# HISTORIC PRESERVATION REVIEW BOARD STAFF REPORT AND RECOMMENDATION

Property Address:	2422 North Capitol Street NW	(X) Agenda
¥ •	Bloomingdale Historic District	( ) Consent Calendar
	G	( ) Denial Calendar
		( ) Concept Review
		(X) Permit Review
Meeting Date:	October 22, 2020	(X) Alteration
H.P.A. Number:	#20-461	( ) New Construction
		( ) Demolition
		( ) Subdivision

Applicant Darren Camody, on behalf of owners 2422 North Capitol St LLC, seeks permit review for adding a third story to the two-story rowhouse at 2422 North Capitol Street NW, a contributing property in the Bloomingdale Historic District. Permit plans were prepared by Stryker Sessions, RA.

Figure 1, Flag test at 2422 North Capitol Street NW from across the street.

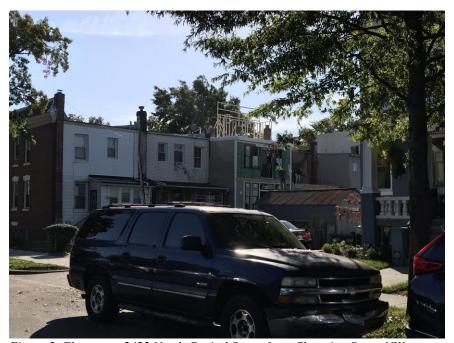
A third-floor addition is proposed to be added on top of the two-story house. It would be in conjunction with a rear addition already under construction and span nearly the full length of the house. The front of the addition would be set back nine feet from the front façade. With its front parapet it would be 8 feet taller than the ridge of the existing mansard roof. The front would be clad in beveled siding and include a pair of double hung windows. The rear of the new third floor would align with rear addition under construction and include a gallery of porches at each floor. A flag-test of the proposal has been erected and inspected by staff (Figures 1 and 2).

The proposed addition would produce a prominent incompatibility in a generally intact and uniform group of houses that is highly characteristic of the Bloomingdale Historic District. The flag test clearly shows that the proposed addition would stand starkly above the houses on this end of the row. Occasionally some accommodation can be made by reducing the size of the addition and setting it back away from the front as much as possible, but in this case the rear of the addition would also be prominently visible from Channing Street and the alley behind the house. The impact on the rear of the row would be just as prominent. Due to the simplicity of the interior plan and construction type, demolition of load bearing features and floor systems would not be substantial.

The HPO recommends that the Board find the proposed third-story addition to 2422 North Capitol Street NW is not consistent with the purposes of the preservation law because it is not compatible with the character of the historic district.
